Meghan Dufresne, LEED AP Institute for Human Centered Design 200 Portland Street, 1<sup>st</sup> Floor Boston MA 02114

IHCD has reviewed the Concord Middle School DD Progress Set dated 04.15.22 and provided comments. Issues having to do with code compliance are highlighted in red; recommendations having to do with enhanced usability are highlighted in purple; and inclusive design recommendations are highlighted in green.

#### CONCORD MIDDLE SCHOOL

DD PROGRESS SET 04/15/2022 19153

1 REFERENCE PLAN - LOWER LEVEL
SCALE: 3/64" = 1'-0"

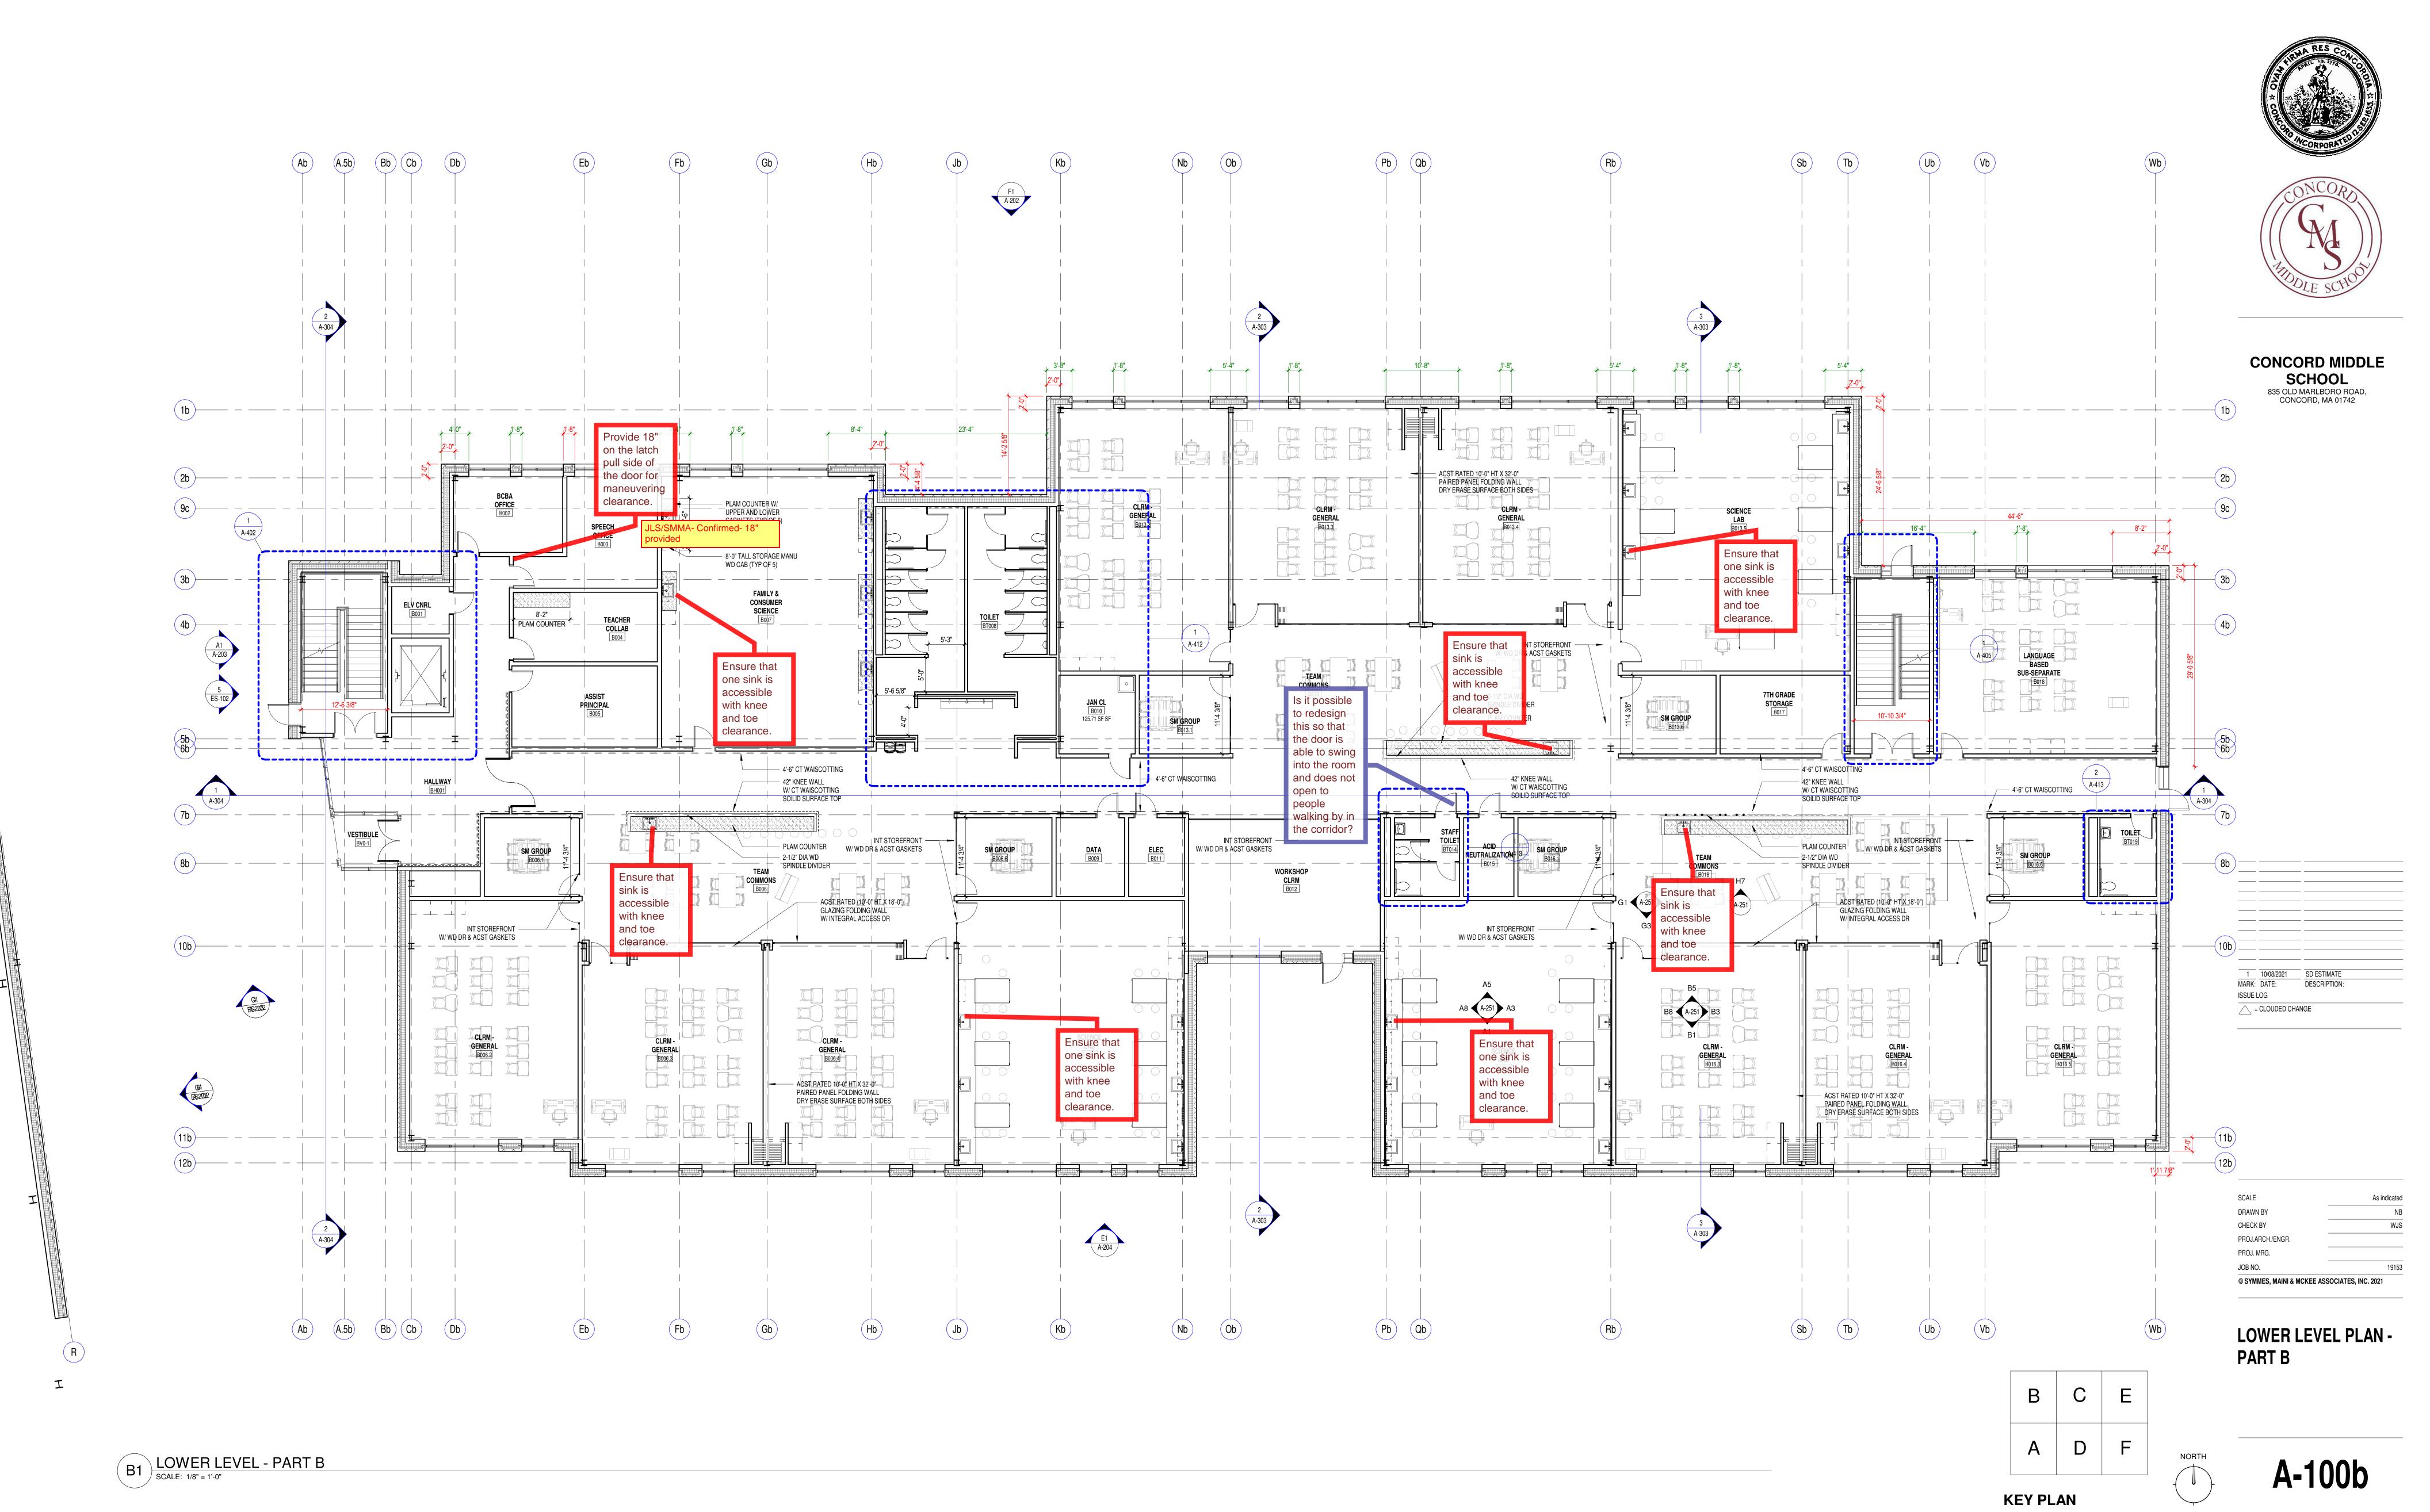
need more privacy.

People using the lavatory may feel very exposed with their backs open to the hall. Recommend providing dividers at the lavatory. Recommend providing a single-user toilet room adjacent to this toilet room for users who

**ENTRY LOBBY LOOKING WEST**

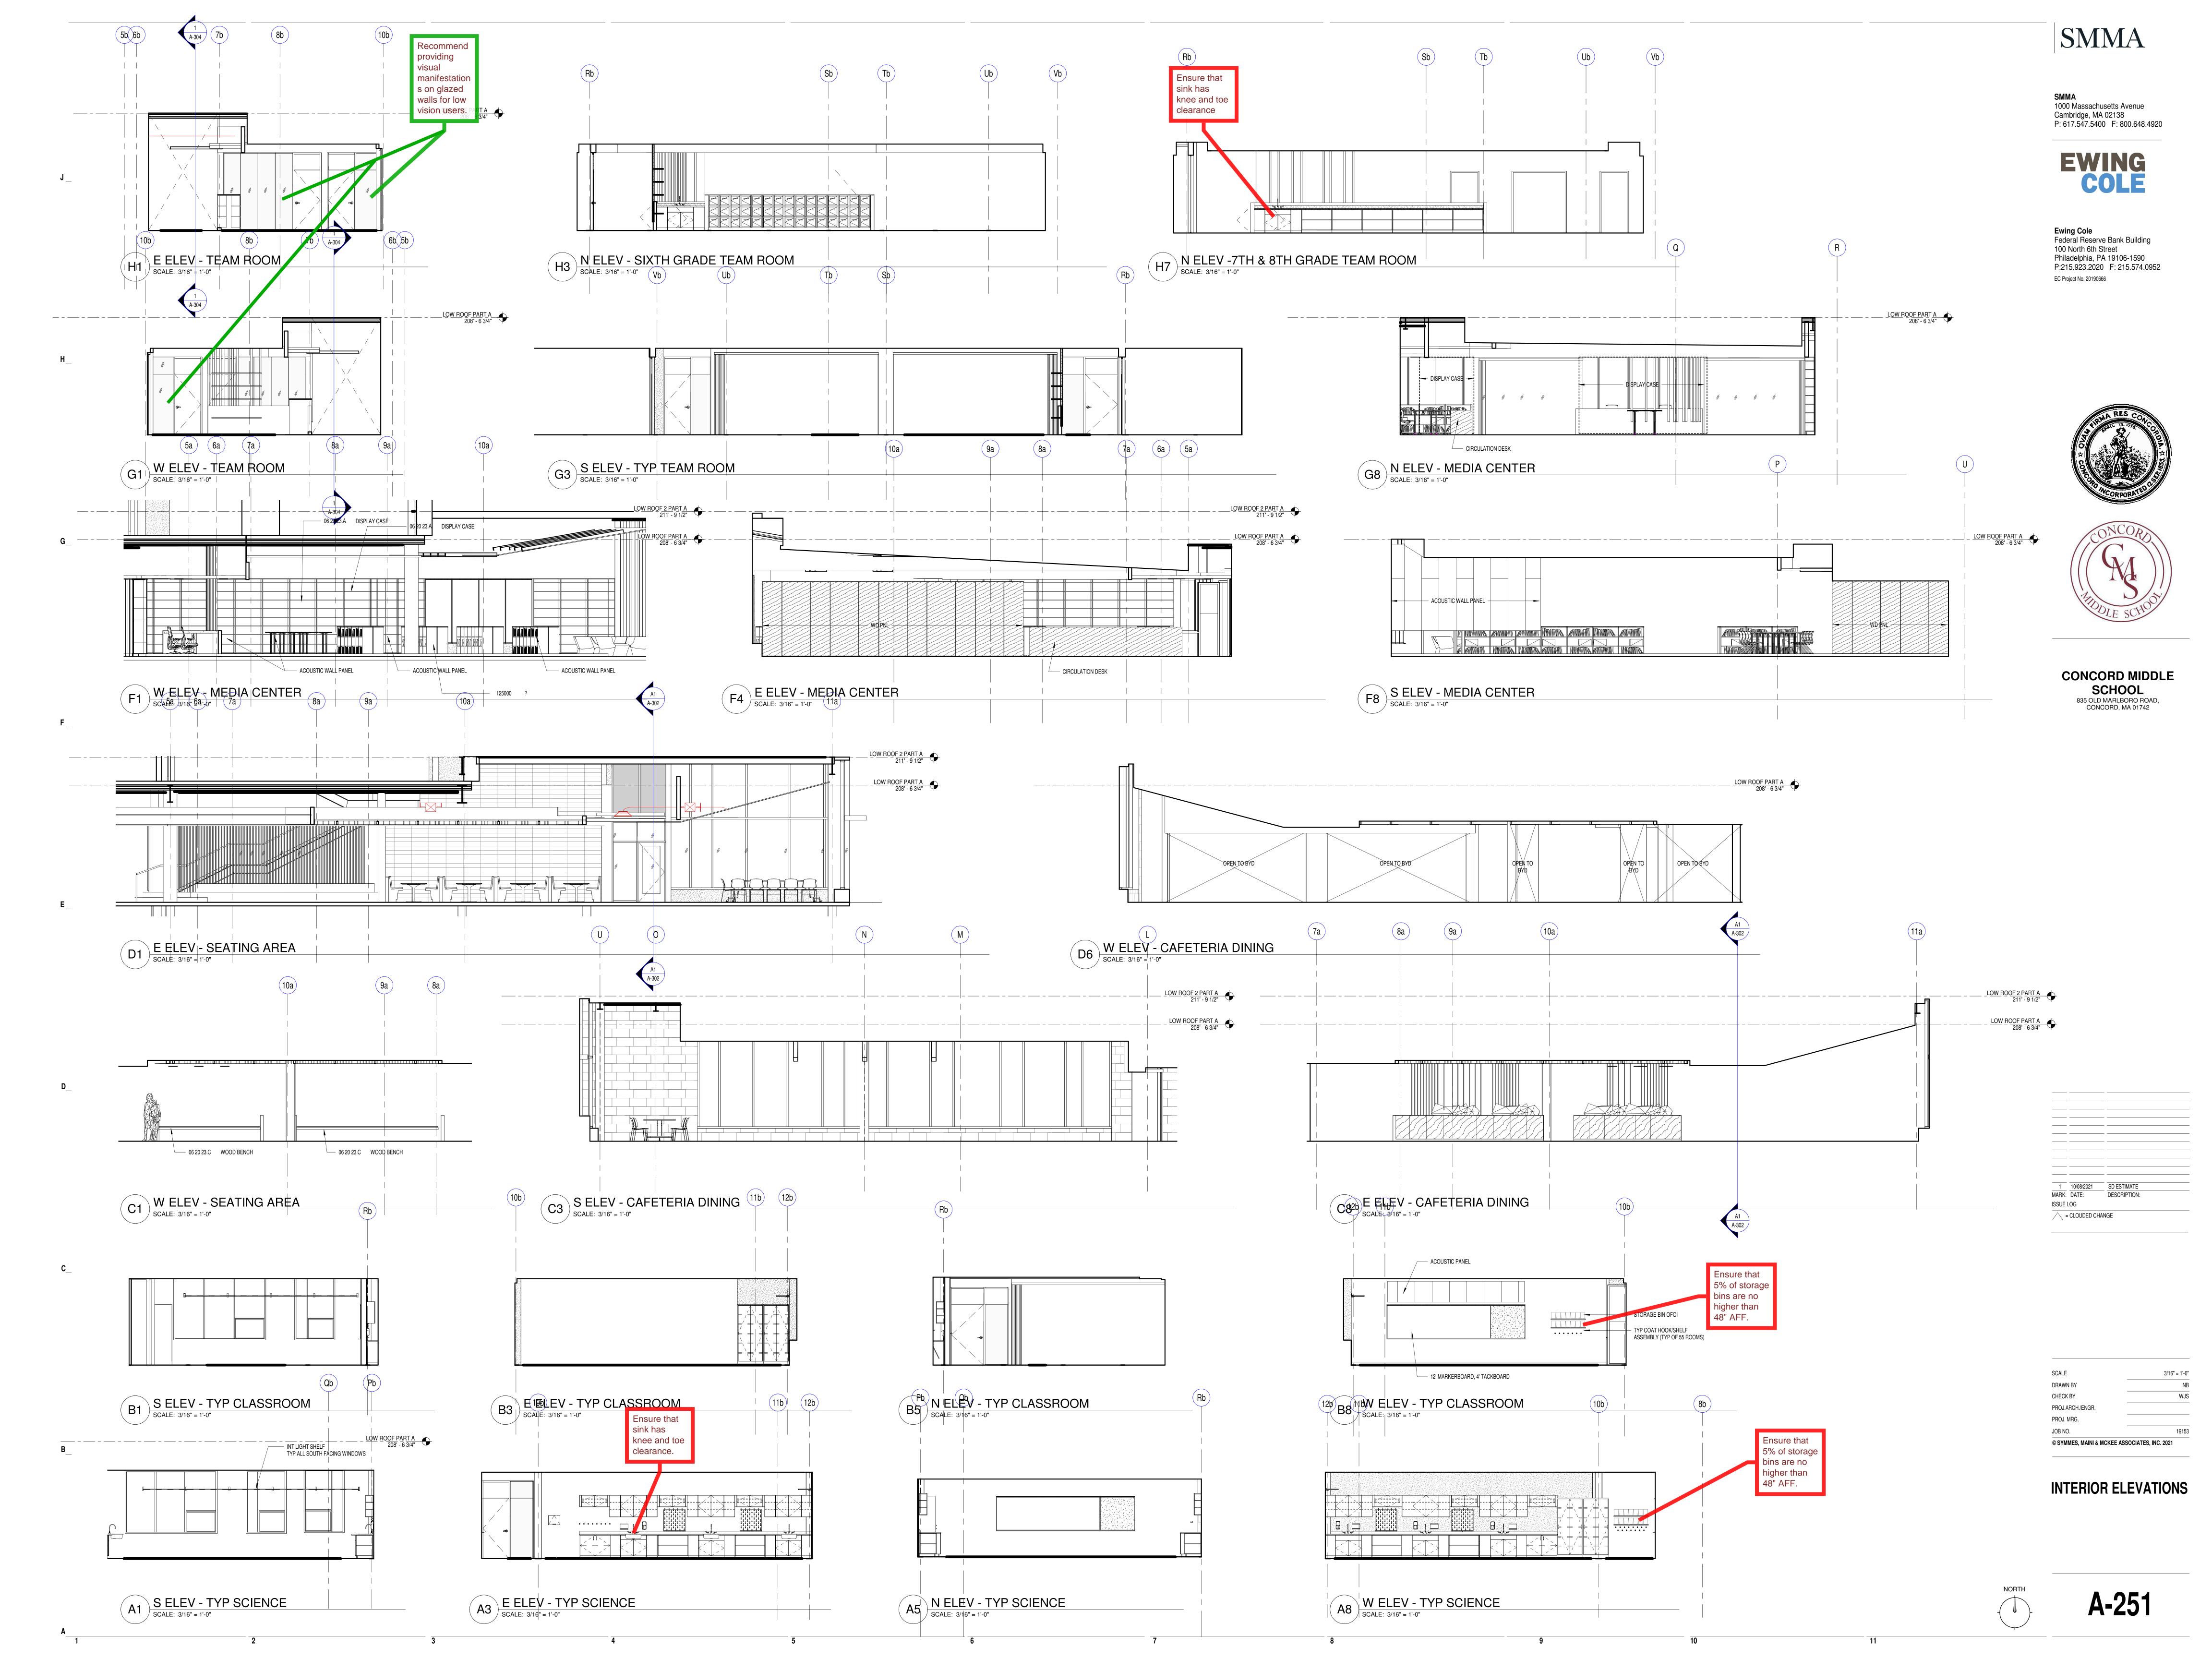
s on glazed walls for low

WINDOW TYPES
SCALE: 1/2" = 1'-0"

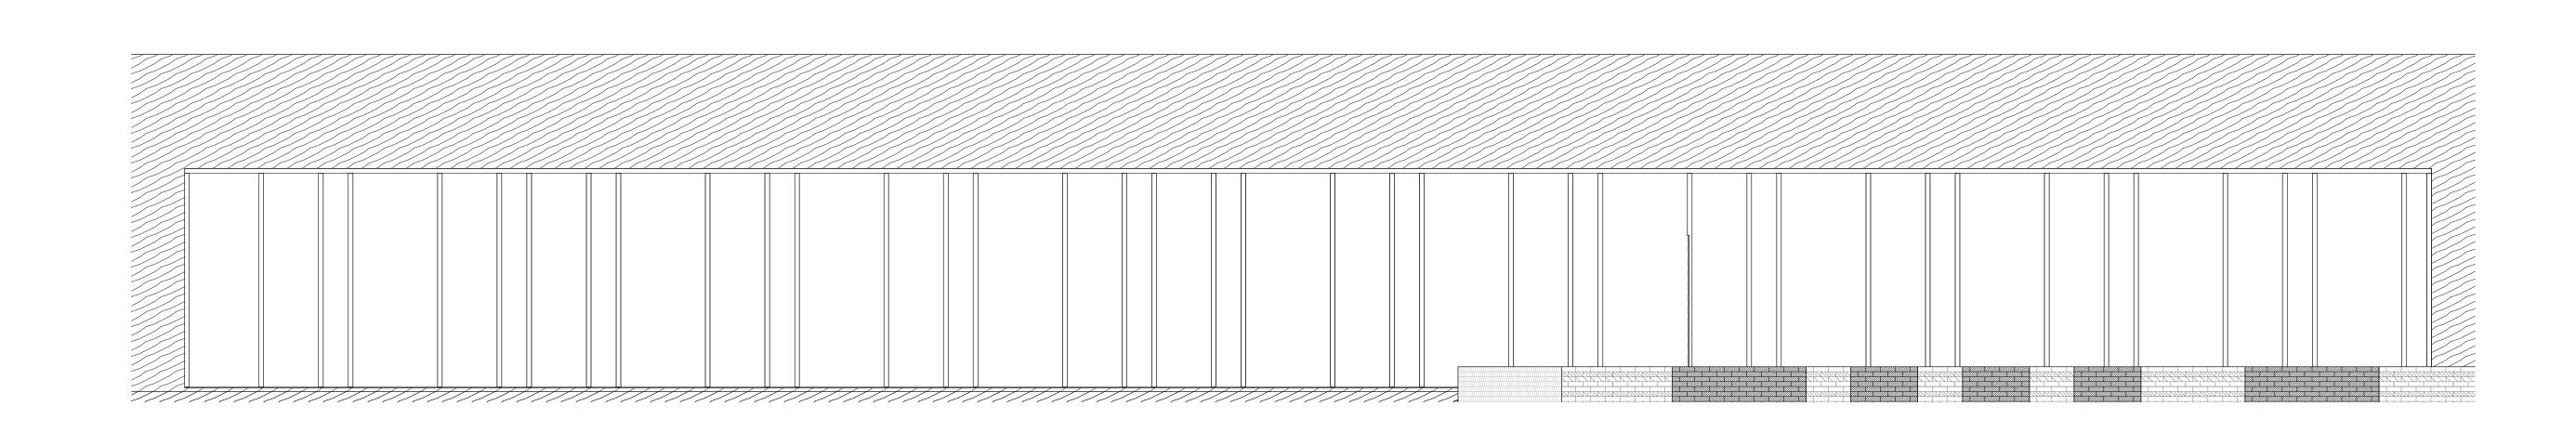
Ensure that the operable part of all windows is within the reach range per the ADA OPERABLE WINDOW OPERABLE WINDOW OPERABLE WINDOW OPERABLE WINDOW FIXED WINDOW В A FIXED WINDOW OPERABLE WINDOW F - NOT

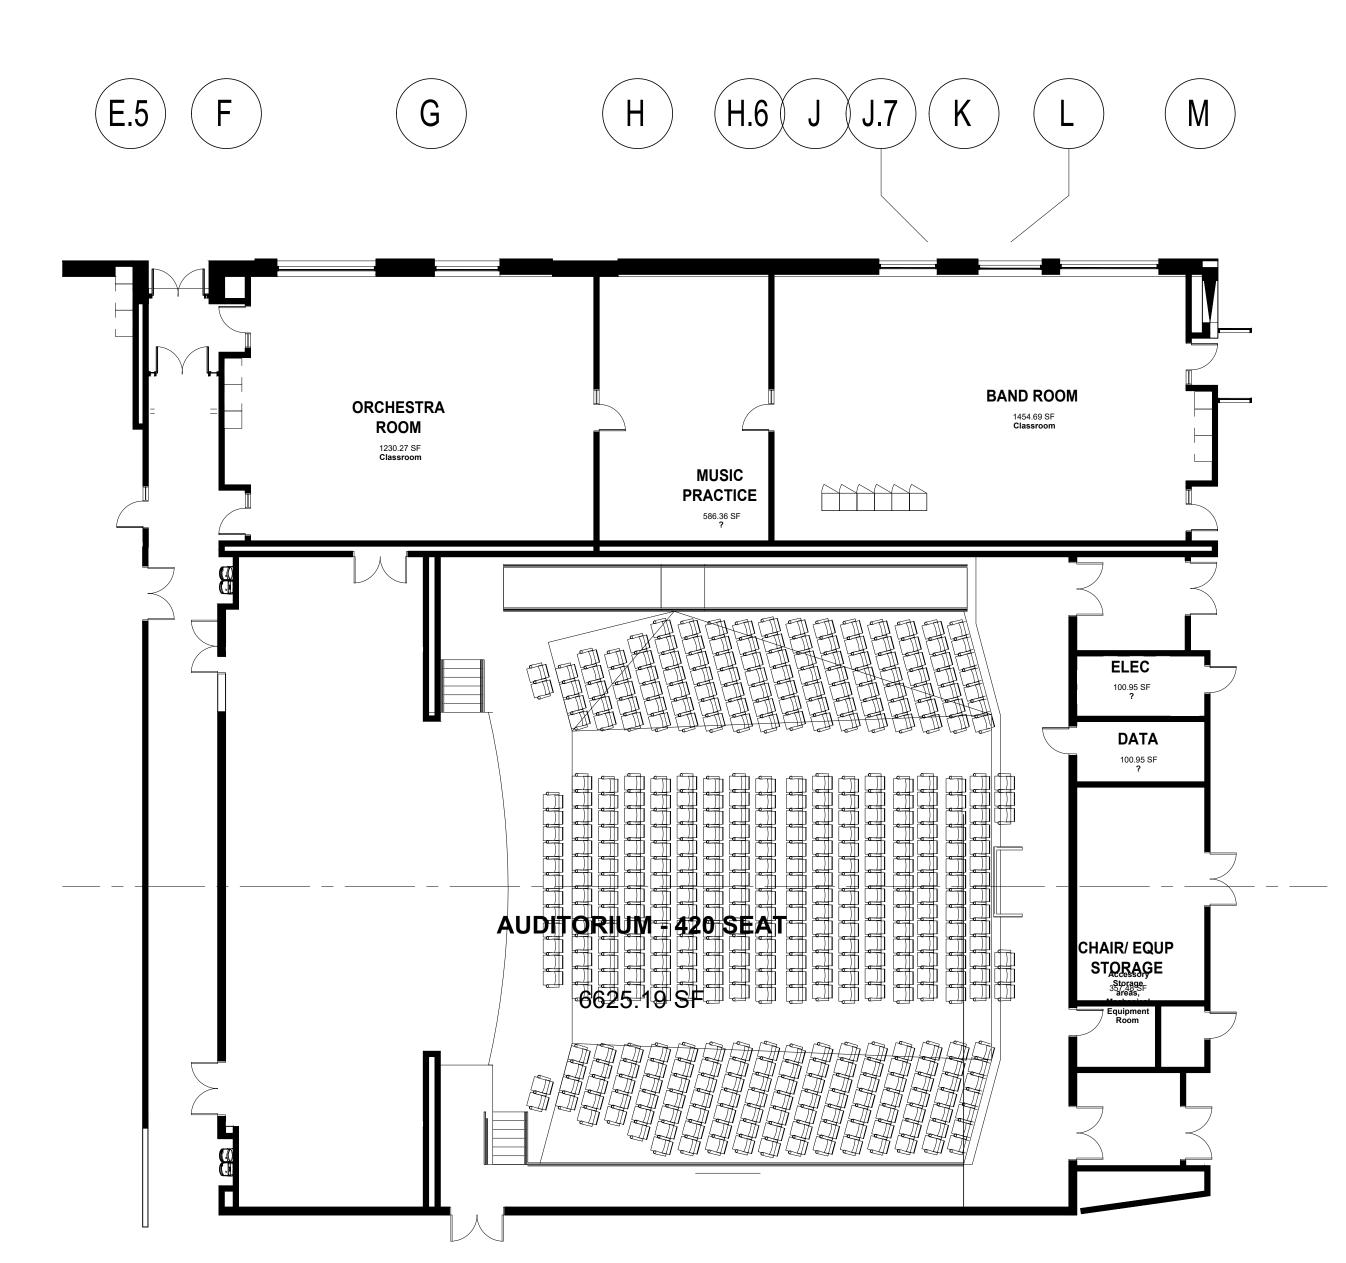
## lighting for interpreter.
